Project	<b>IEEE 802.16 Broadband Wireless Access Working Group</b> < <a href="http://ieee802.org/16">http://ieee802.org/16</a> >	
Title	<b>A MAP IE for H-ARQ and SDMA Allocation in AAS Zone</b>	
Date Submitted	<b>2005-0103-2616</b>	
Source(s)	InSeok Hwang, Jaehee Cho, Seungj Maeng, JangHoon Yang, Hoon Huh, SangHoon Sung, Jaeho Jeon, Soonyoung Yoon <b>Samsung Electronics, Inc.</b>	<a href="mailto:is91.hwang@samsung.com">is91.hwang@samsung.com</a>
	Ran Yaniv, Tal Kaitz <b>Alvarion Ltd.</b>	<a href="mailto:ran.yaniv@alvarion.com">ran.yaniv@alvarion.com</a>
	Dave Pechner, Doug Dahlby, Todd Chauvin <b>ArrayComm Inc.</b>	<a href="mailto:dpechner@arraycomm.com">dpechner@arraycomm.com</a>
Re:	Call for reply comments ( <b>Original Comment # 2189</b> )	
Abstract	A new efficient Normal MAP IE supporting for Hybrid ARQ and SDMA allocation in AAS zone is proposed.	
Purpose	Adoption in <b>IEEE 802.16e_D6</b>	
Notice	This document has been prepared to assist IEEE 802.16. It is offered as a basis for discussion and is not binding on the contributing individual(s) or organization(s). The material in this document is subject to change in form and content after further study. The contributor(s) reser

Fig. 1. Proposed SDMA Allocation Scenario

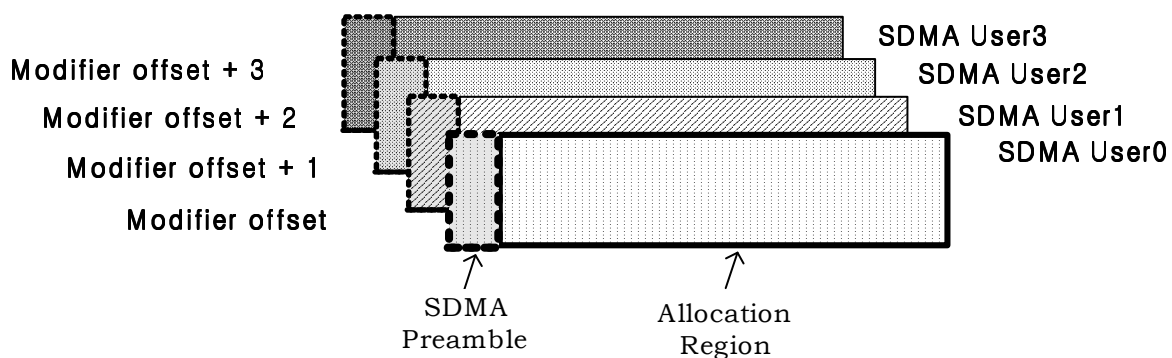
The burst allocation region of SDMA users can be fixed for scheduling simplicity and lower signaling overhead. In addition, modifier index for SDMA preamble can be extracted from description order of SDMA users. The proposed solution can be summarized as follows

- 1) Introduce Extended IUC in DL/UL MAP for SDMA allocation (not available yet)

- 2) Use '1' of '5' reserved bits in AAS\_IE() to specify modifier type, "Time" or "Freq." shift
- 3) Describe the shared 2D (DL) or 1D (UL) allocation regions
  - Specify {CID, modulation/coding schemes (IUC or H-ARQ)} fields
  - ~~Implicitly assign SDMA preamble index with description order of CIDs. Due to limited length of Extended IUC, starting offset of preamble modifier is included.~~
  - Optionally include CQICH/ACKCH allocation IE for DL burst and uplink power adjustment IE.
  - **Optionally specify pilot patterns for SDMA users**
- 4) Use a pointer IE for special Sub Map including the all information elements described above.

Figure XXX – Pilot patterns for AAS mode in AMC zone. Symbol offset is relative to the beginning of the zone. Pilot polarity for each pattern is given in brackets.

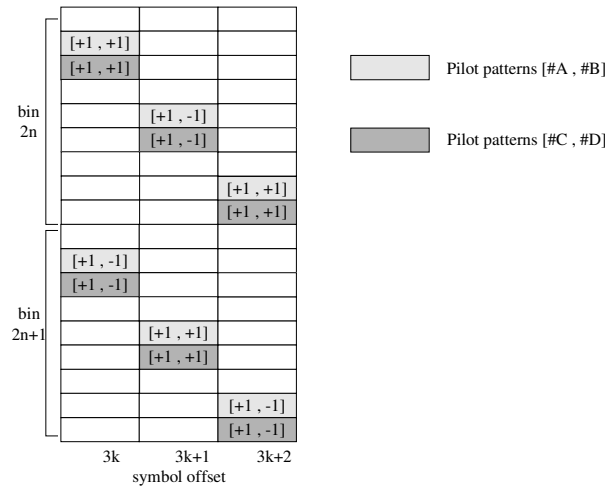
[Add the following new section]

#### 8.4.6.3.2 AMC support for SDMA

The pilots in an AMC AAS zone are regarded as part of the allocation, and as such shall be beamformed in a way that is consistent with the transmission of the allocation's data subcarriers. In an SDMA region, the pilots of each allocation may correspond to a different pilot pattern. A pilot pattern consists of location and polarity. The pilot patterns are depicted in figure XXX. Data subcarriers shall be punctured to obtain patterns #2 and #3. Subcarriers shall only be punctured if there is an allocation associated with the corresponding pattern, as described in the AAS SDMA DL IE() and AAS SDMA UL IE(). Only MSSs that support all four pilot patterns, as indicated by their capability in 11.8.3.7.X, shall be assigned allocations in an SDMA region where pilot patterns #2 and #3 are used. Data subcarriers shall be punctured after constellation mapping in the case of CC encoding, and prior to constellation mapping in the case of CTC encoding. In the latter case, the FEC block shall be truncated to accommodate the punctured subchannel structure, and the data subcarrier enumeration of Eq. (116) shall not be applied. Instead, data subcarriers within a slot shall be enumerated starting from the first OFDMA symbol at the data subcarrier that is lowest in frequency, continuing in ascending frequency order throughout the slot's subcarriers in the same symbol, then going to the next symbol at the subcarrier lowest in frequency, and so on.
